Since this drainage report is the same as that submitted for Filing No. 1, my comments are the same.

FINAL DRAINAGE PLAN

THE RIDGE AT LORSON RANCH

FILING NO. 1: SF 22-XX ← SF224

POND F
WQ POND
OUTLET STRUCTURE DETAILS

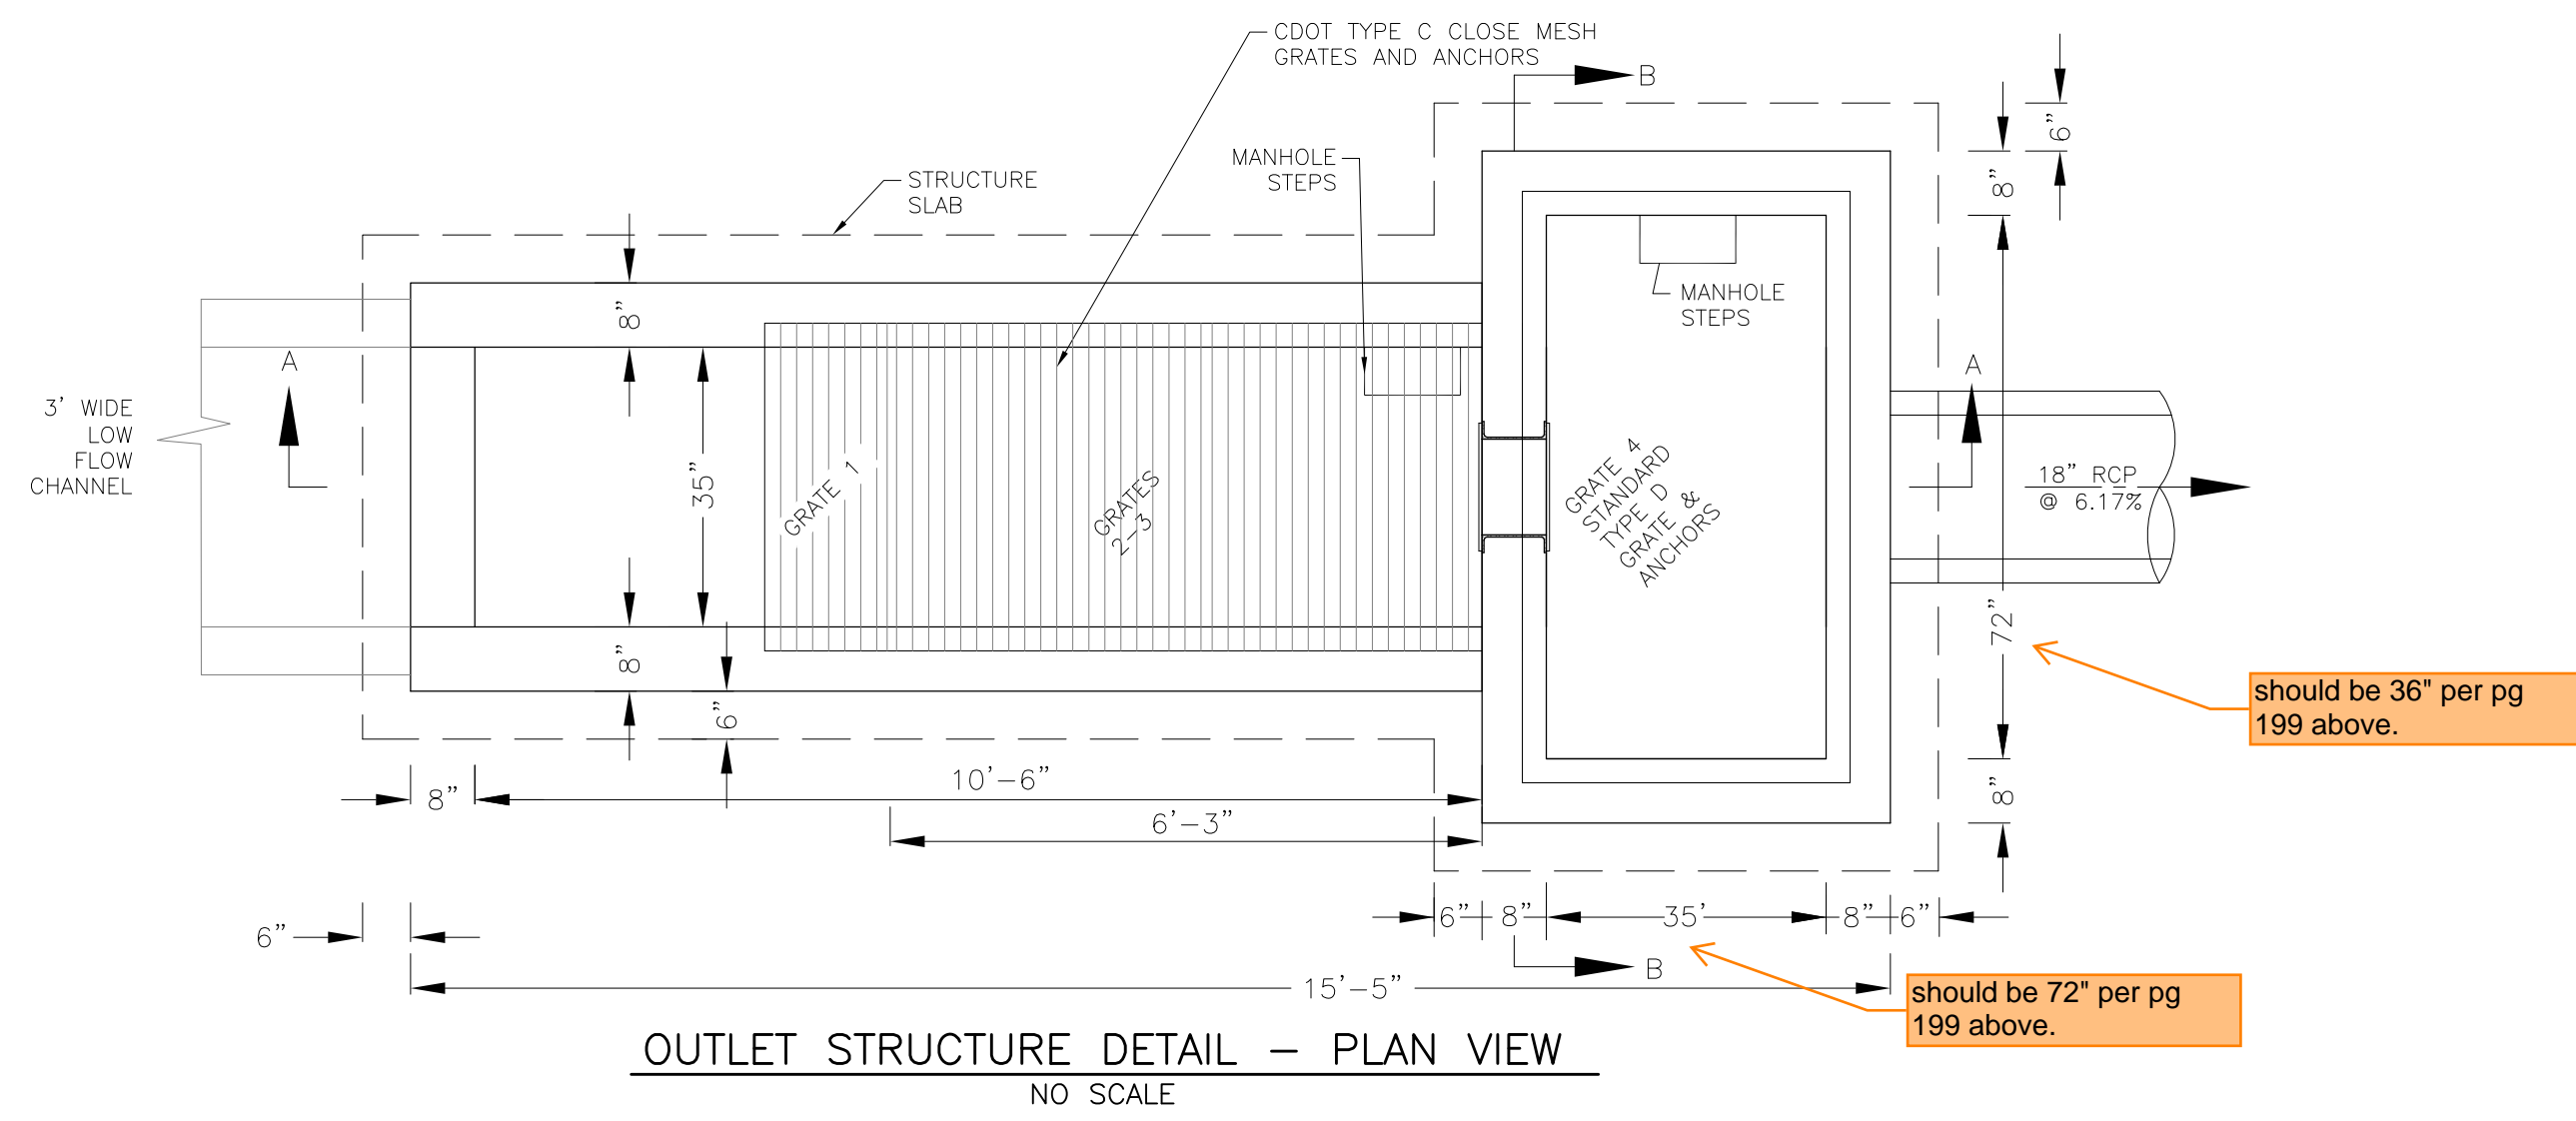
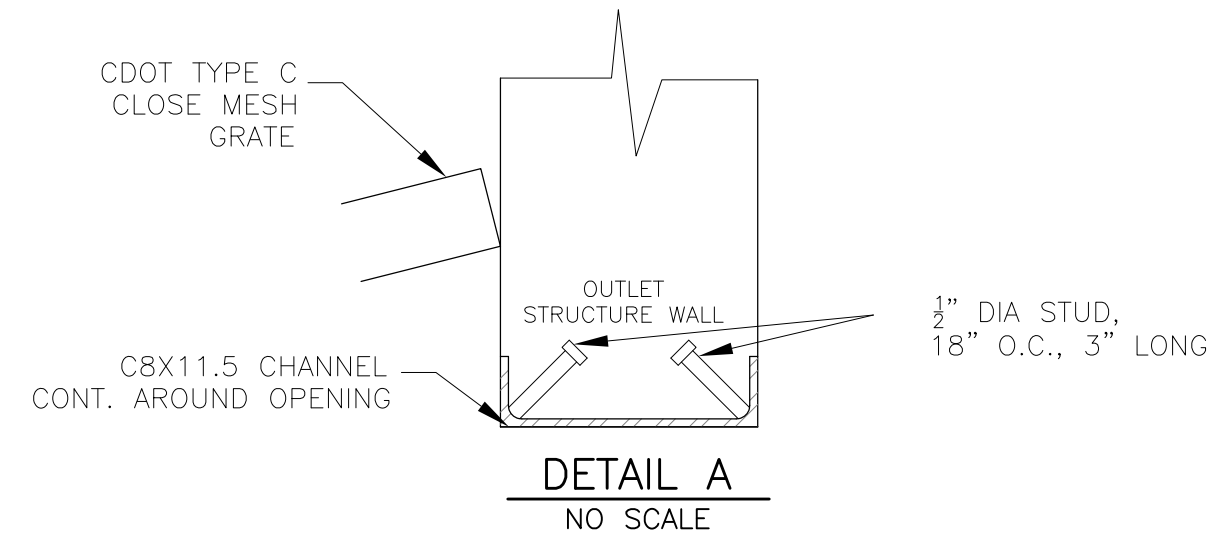
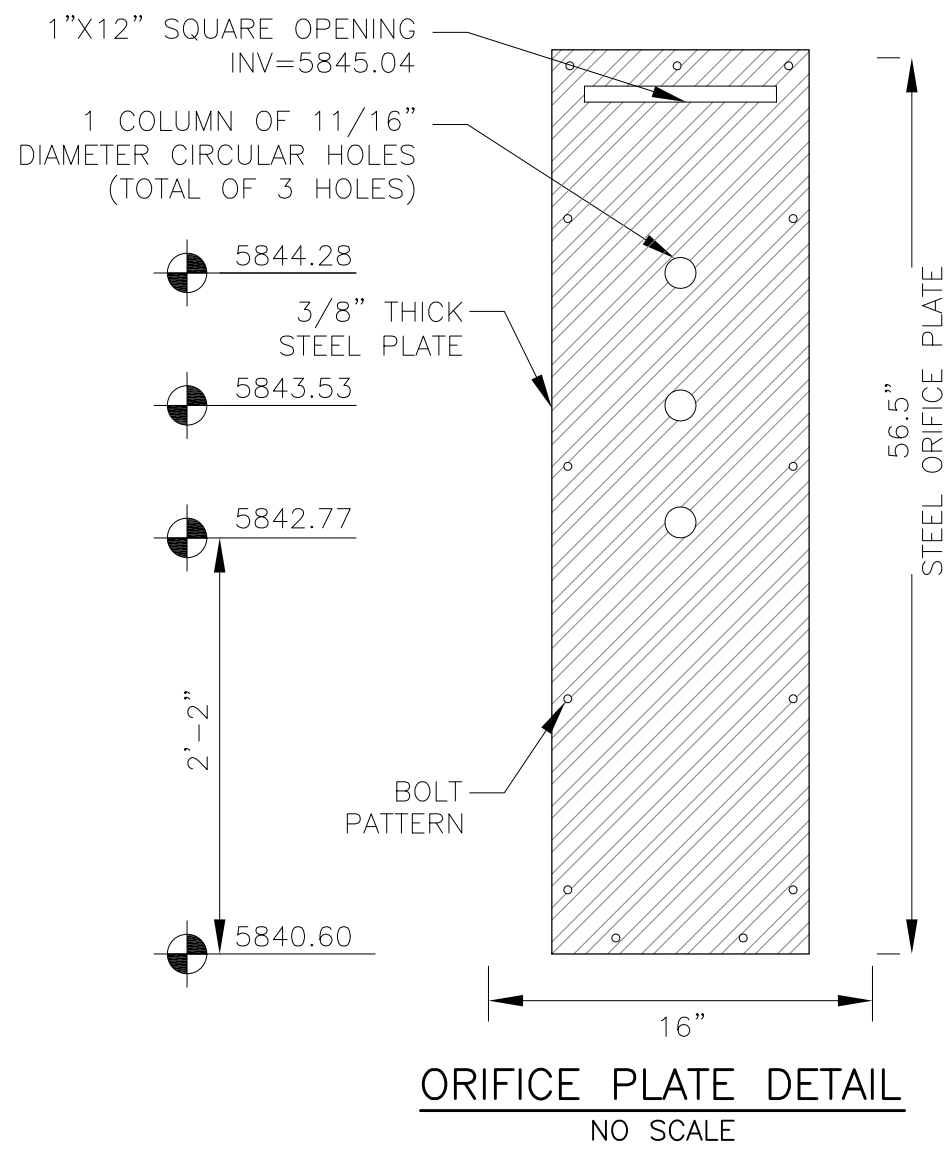
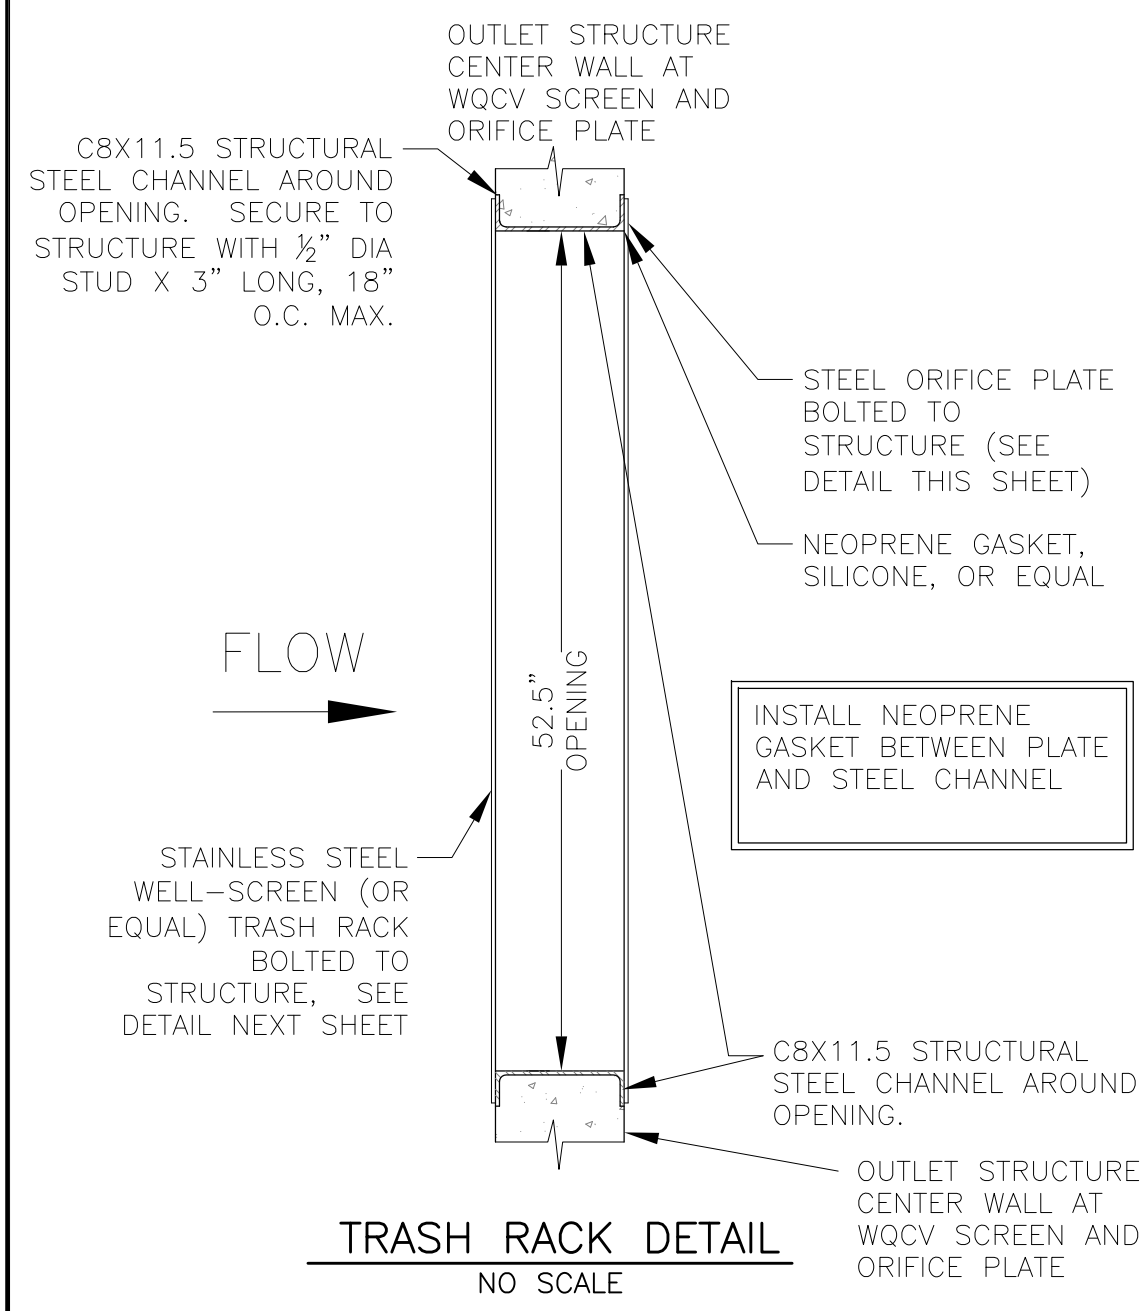
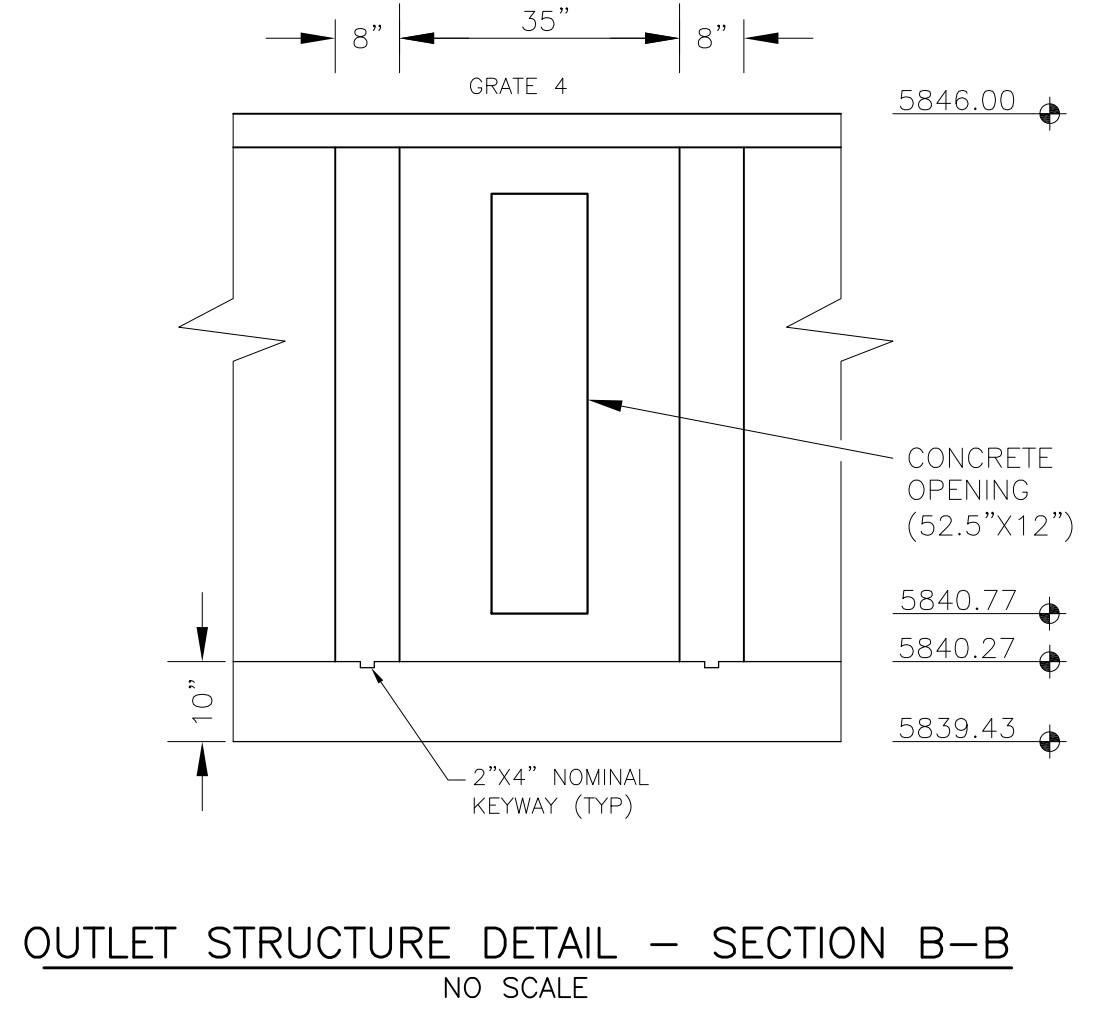
Pg 190 above shows that this should be 72"

MHFD Detail T-12 shows a 3" min between micropool WSEL and the outlet pipe invert.

Consider potential maintenance difficulties with this outlet structure configuration. How will debris and sediment be removed from these two chambers since there is so much volume below the outlet pipe invert?
